1-NSW-69 (Sheet 2 of 2)  
Upper Containment Ventilation  
Unit 4 Return Line

INDIANA MICHIGAN POWER COMPANY  
**DONALD C. COOK**  
NUCLEAR PLANT  
BRIDGMAN MICHIGAN

1-NSW-69-SH2-8

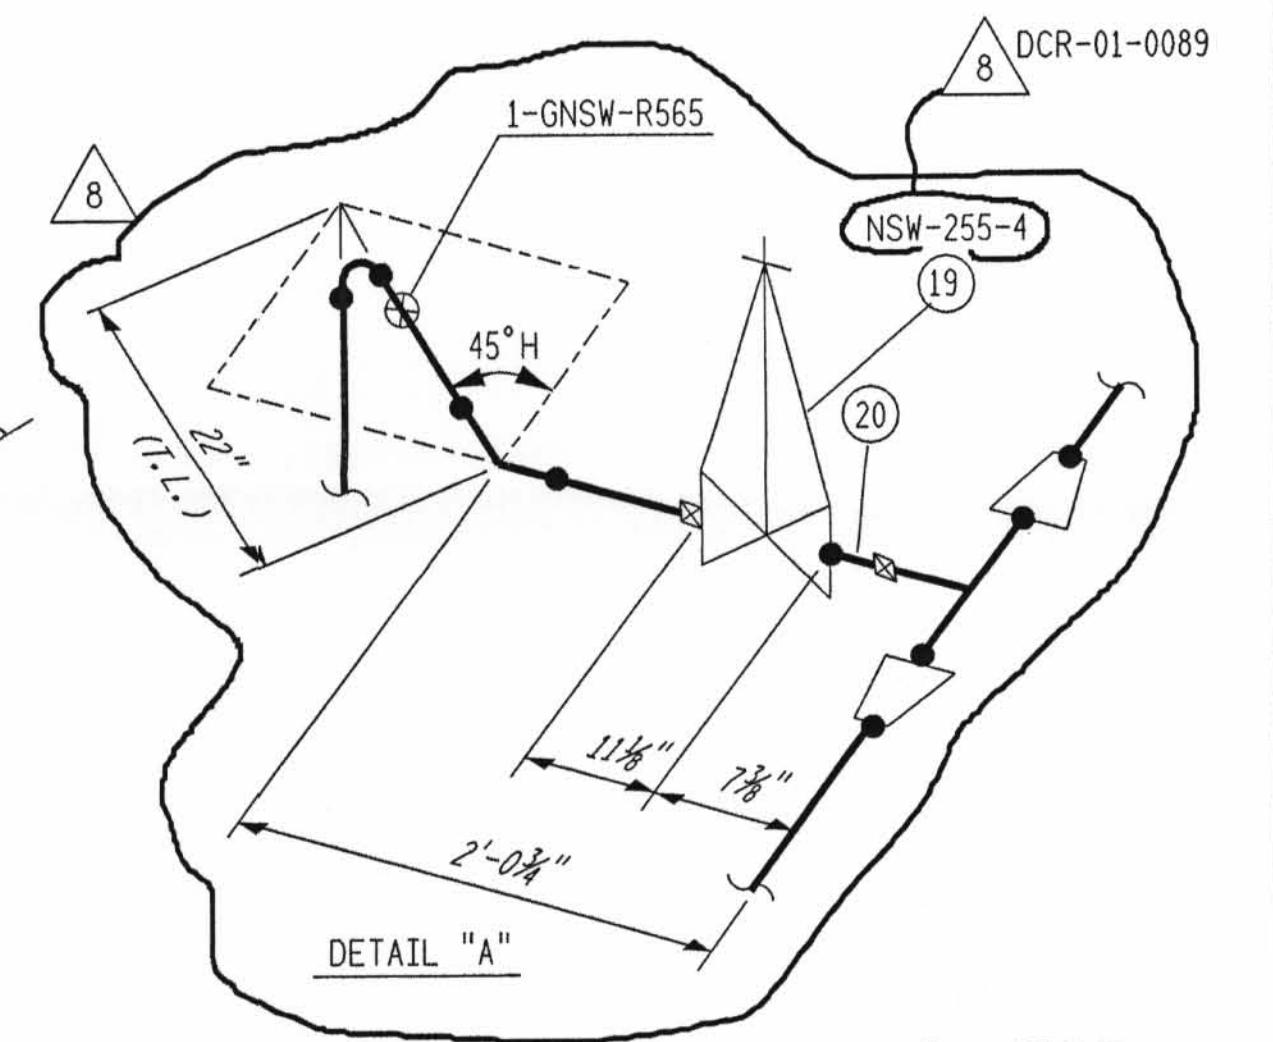
8	4/11/91	REVISED: VA DESIGN NO'S. TO UNIQUE NO'S., EXCEPT ON BOM, PER DCR-01-0089.	NO FIELD ACTION REQ'D.
		ADDED: DETAIL "A"; ITEMS 19 & 20 AND TO BOM; PIPE SUPPORT 1-GNSW-R550, DIM'S 22" T.L. & 2'-0 3/4". RELOCATED: PIPE SUPPORT 1-GNSW-R566. REVISED: DIM'S 6 1/2" TO 7 3/8" & 8 3/8" TO 11 1/2". DELETED: ITEMS 4-7; DIM'S MIN (TYP), 10 1/2", 8 1/2" & 6 1/2" PER 1-DCP-4845 REV 0. GM/CD/ENJ/WCM
